# City Of New London

### ADDENDUM # 1

Proposal No.: **2025-03 CONL**

**Briggs Brook and Fulton Park Improvements**

**BRIGGS BROOK & FULTON PARK IMPROVEMENTS**  
PREPARED FOR THE CITY OF NEW LONDON  
**FOUNDATION & HELICAL PILE PLAN**  
STATE PIER ROAD & CRYSTAL AVENUE NEW LONDON, CT

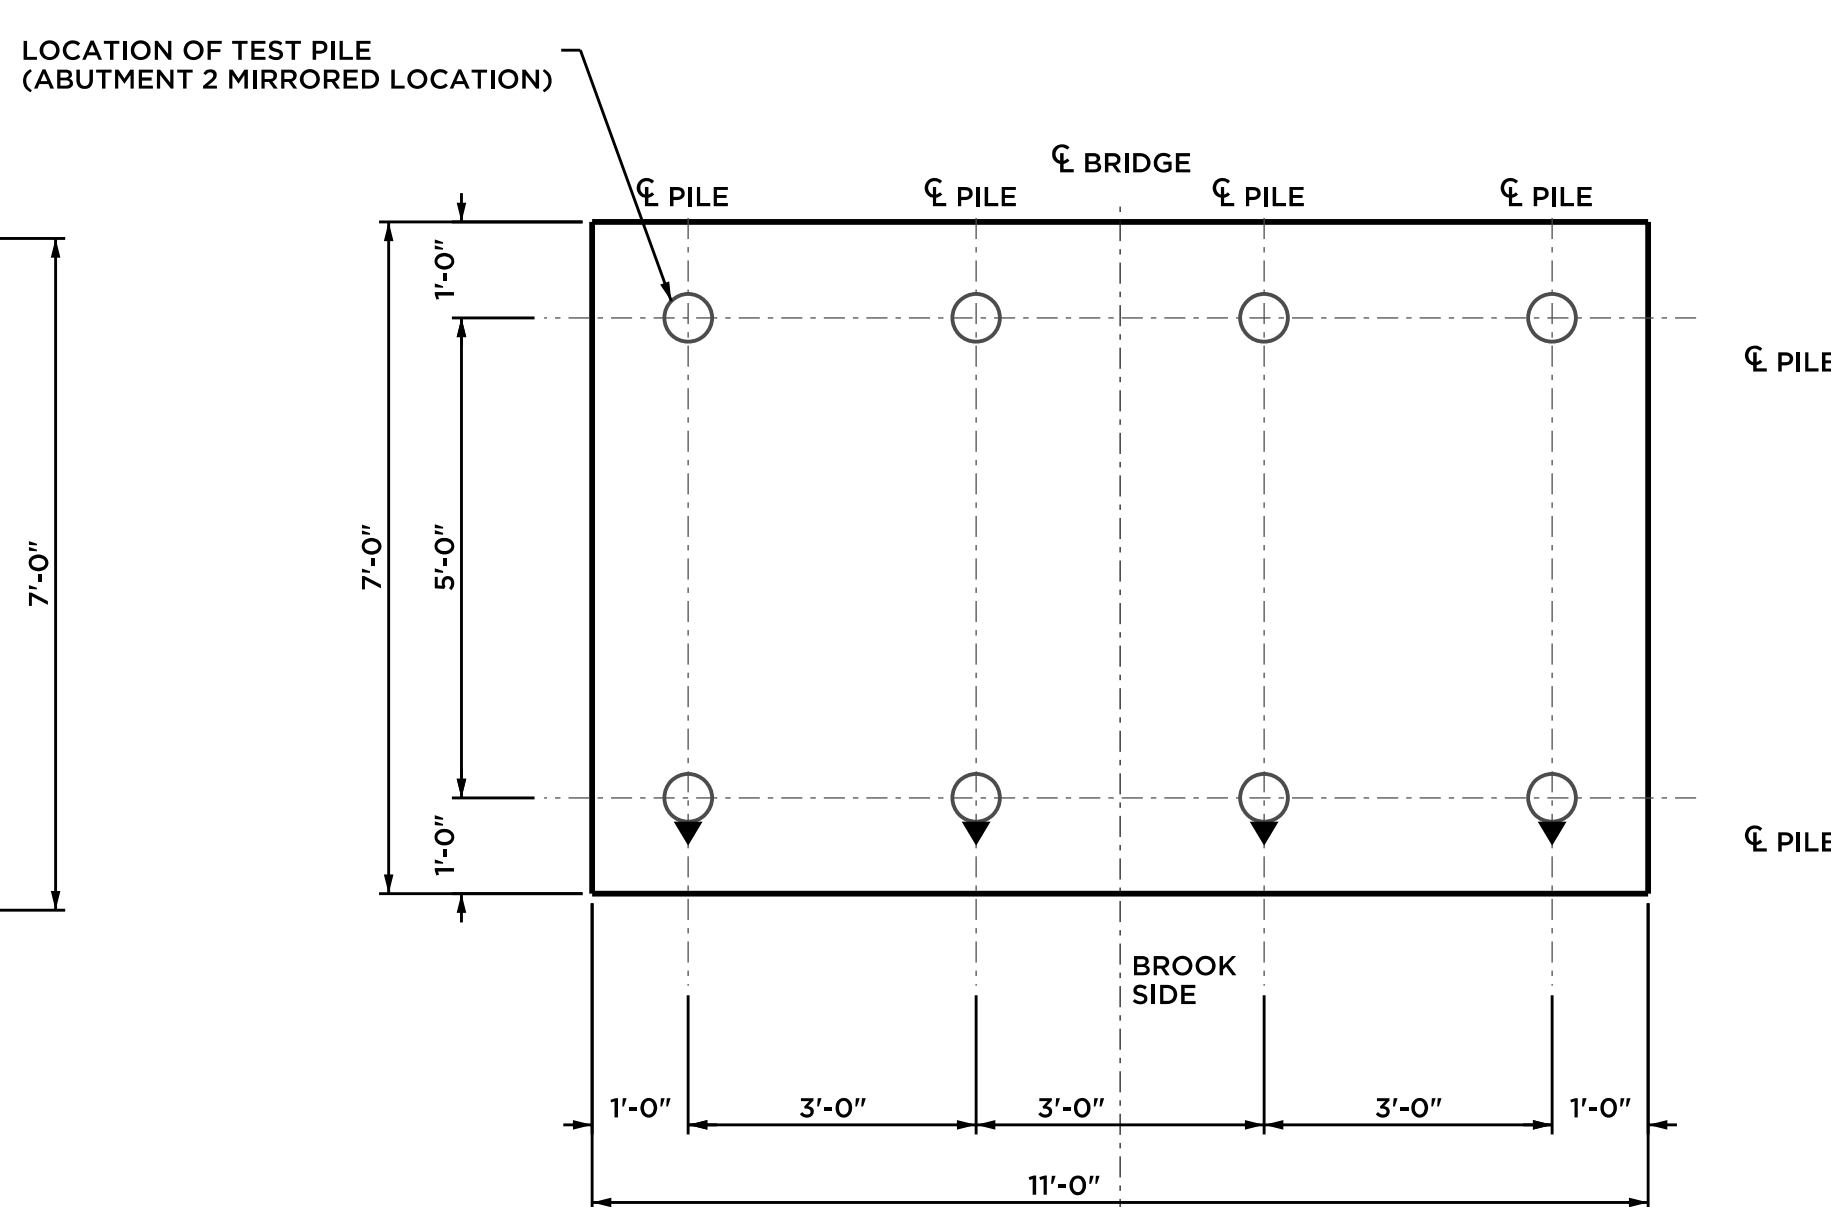
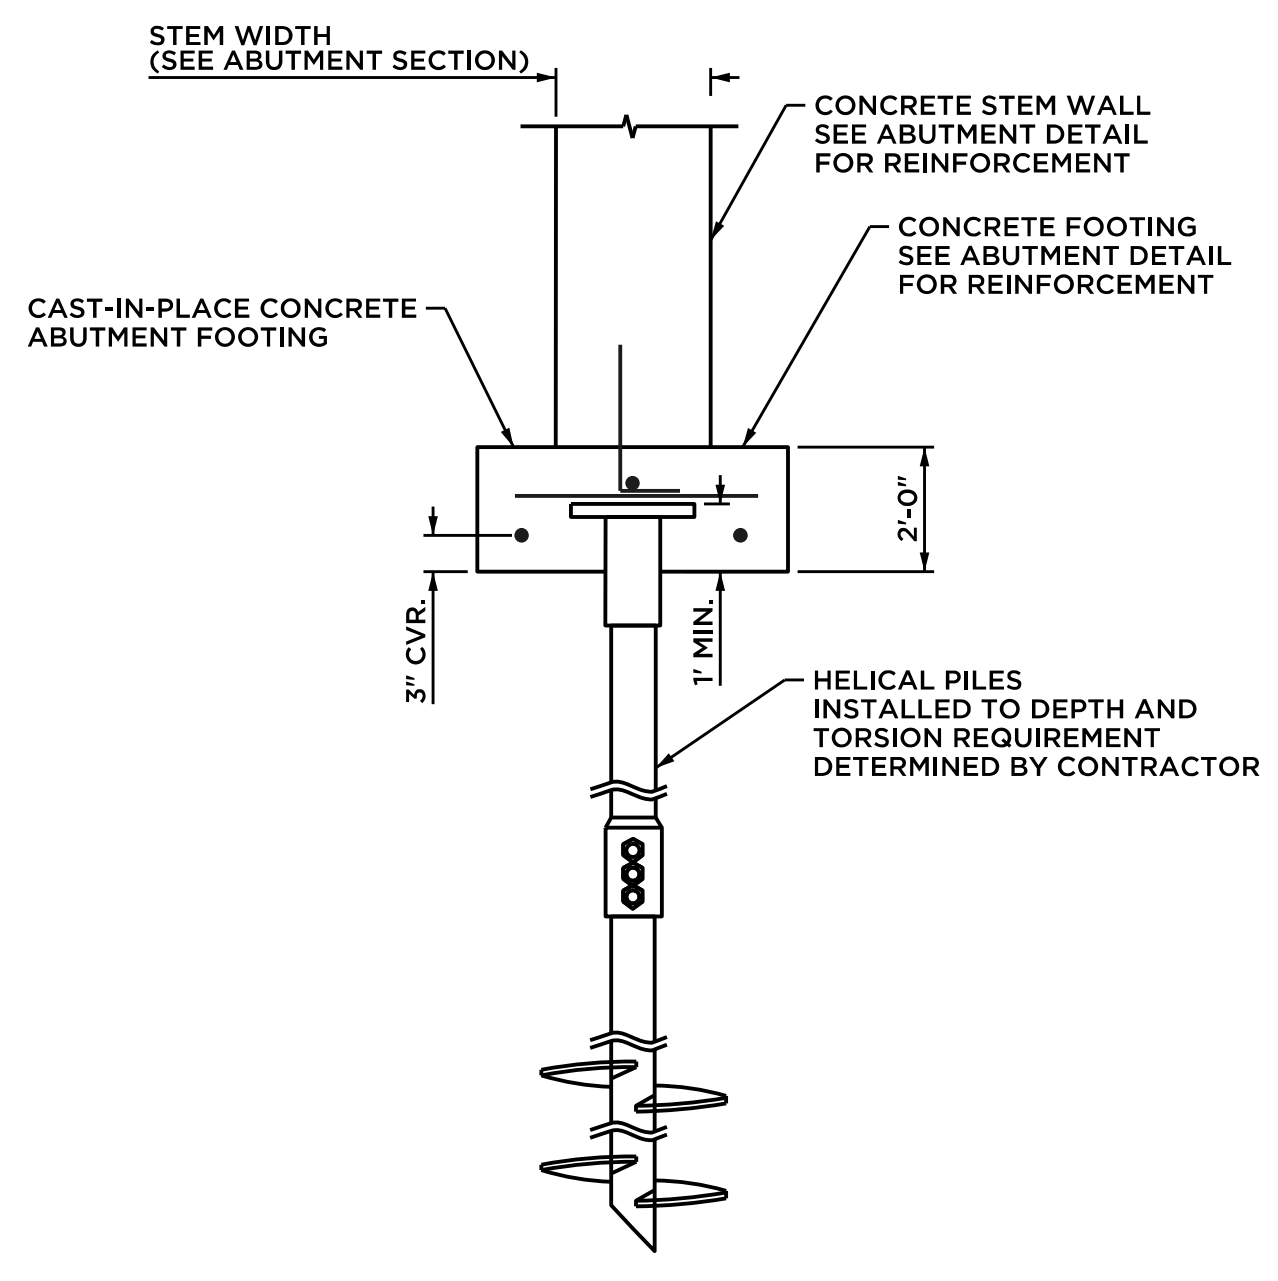
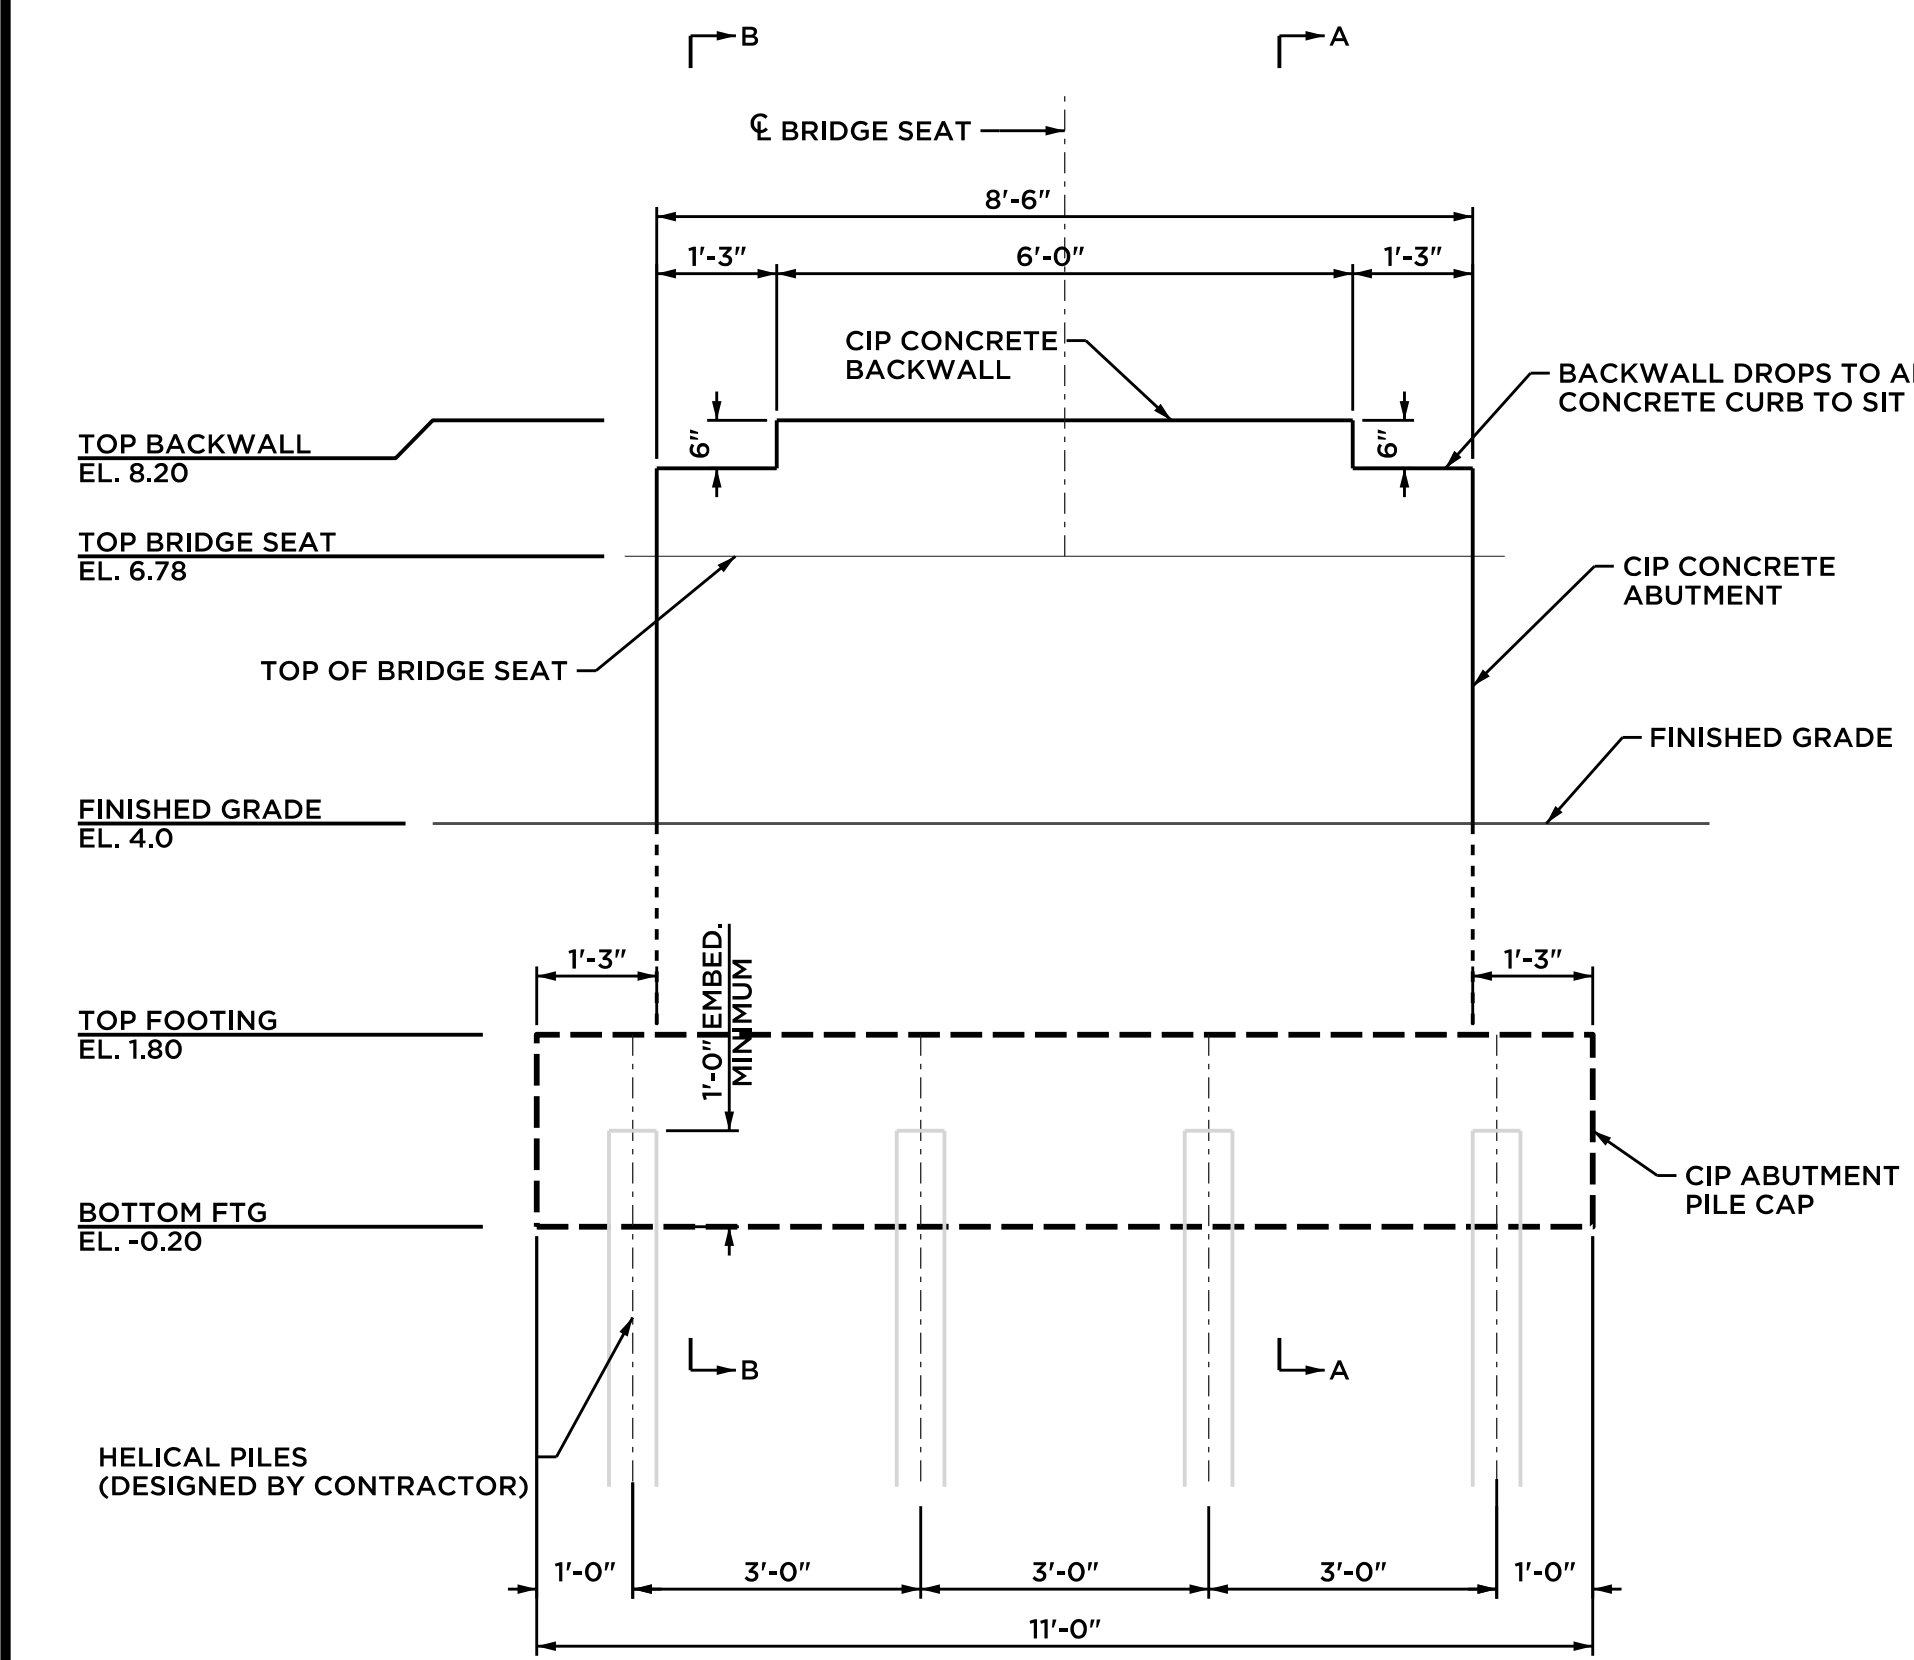
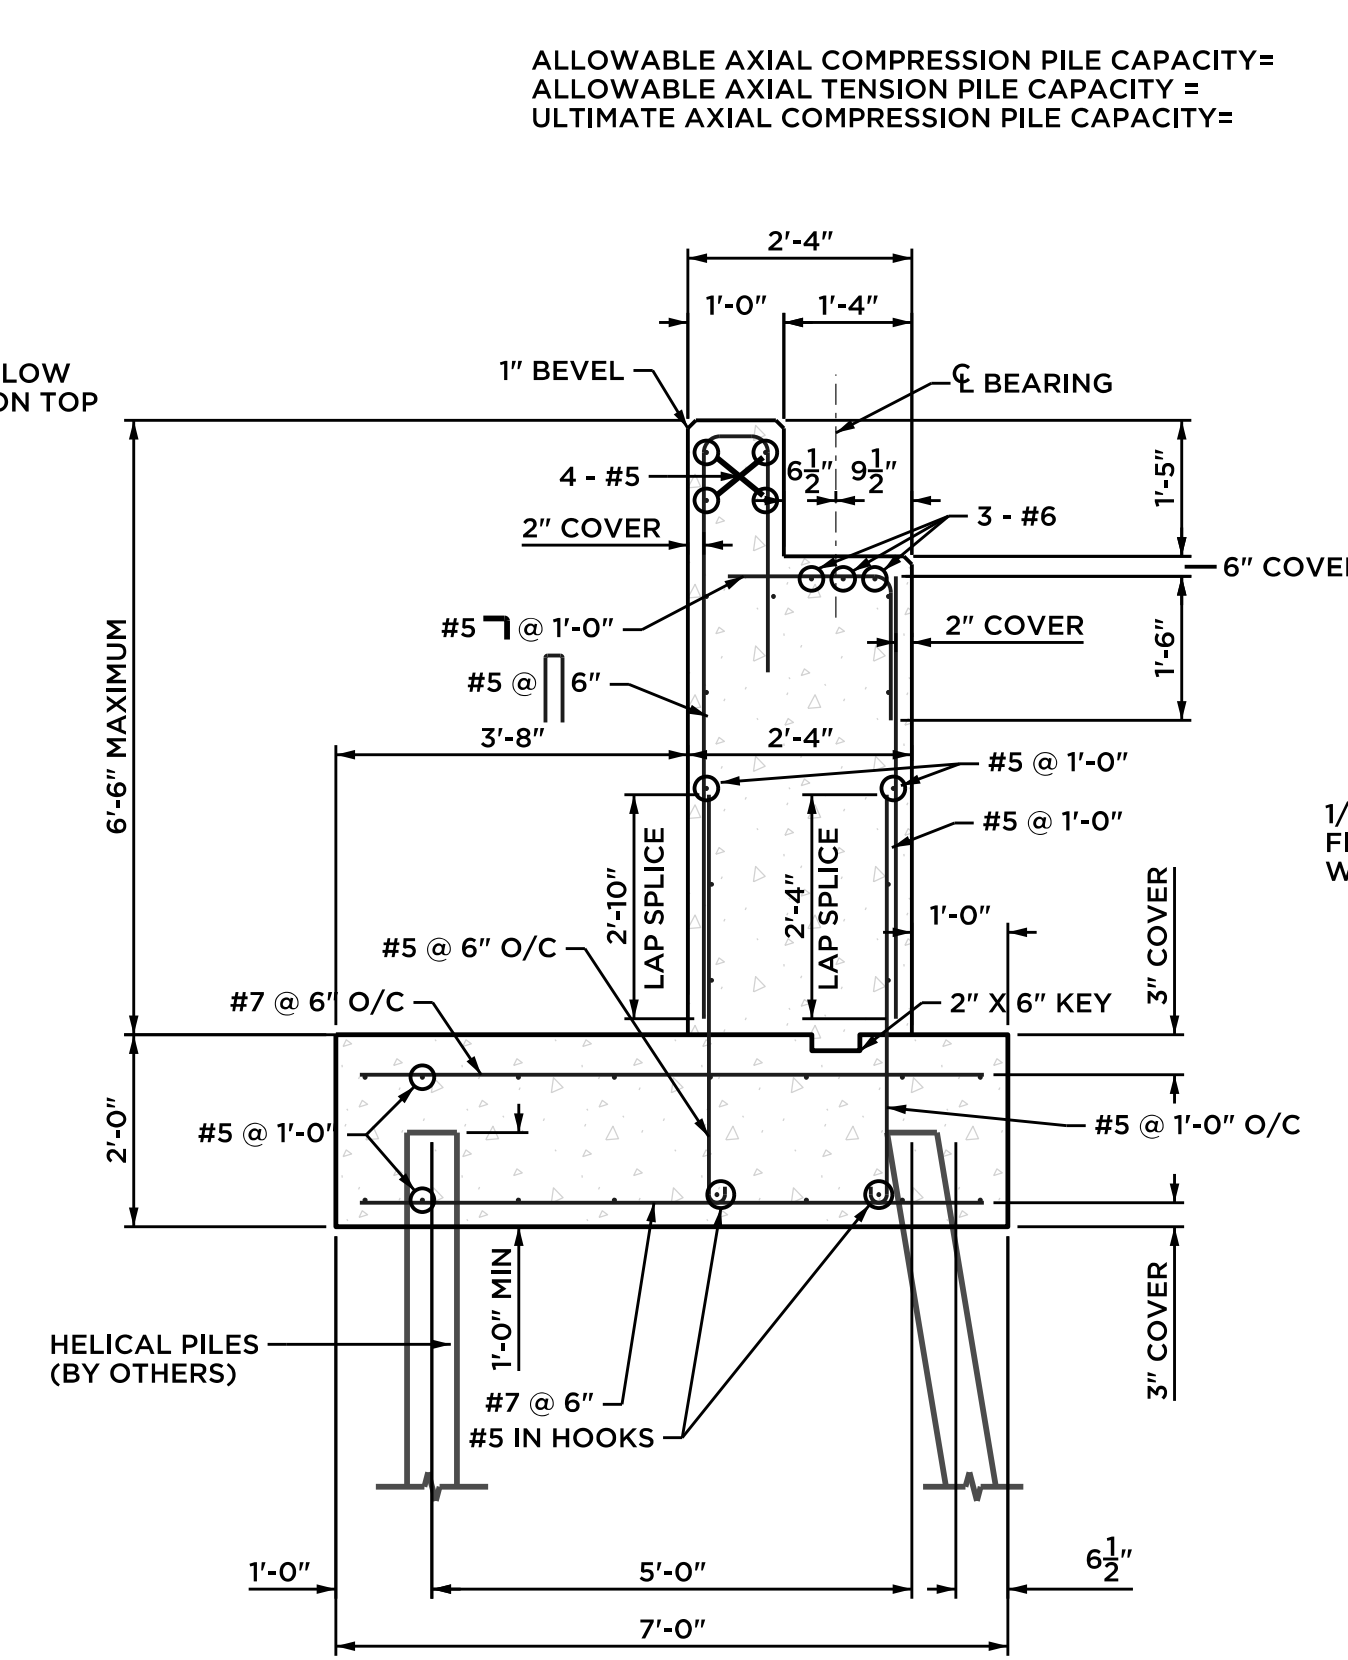
Q3. Specifications 31 66 15 2.1.2 call for sch 80 pipe 3.5" x 0.300" shaft, sheet 9 of 12 calls for 2.875" x 0.276" shaft. Should we follow the more stringent minimum?

Q4. Sheet 9 of 12 calls for a Carbide Rock It tip. This tip is available on square shaft leads. Please advise if the Carbide Rock It tip is required.

Q5. Sheet 9 of 12 note 3 calls for 10/12/14 helix configuration. Note 8 calls for a minimum 3d spacing of piles. Pile cap layout suggests a 3ft pile spacing. Should we assume pile configuration or pile spacing should be used?

*A3. Please refer to revised plans/specs/bid form attached.*

*A4. Please refer to revised plans/specs/bid form attached.*

*A5. Please refer to revised plans/specs/bid form attached.*

- PILE MATERIAL:  
PILE LEAD SECTIONS RS2875.276 TRIPLE HELIX (10/12/14)  
PILE EXTENSIONS RS2875.276 (5', 7', AND 10' LENGTHS)  
HARDENED PILE TIP CARBIDE ROCK-IT TIP
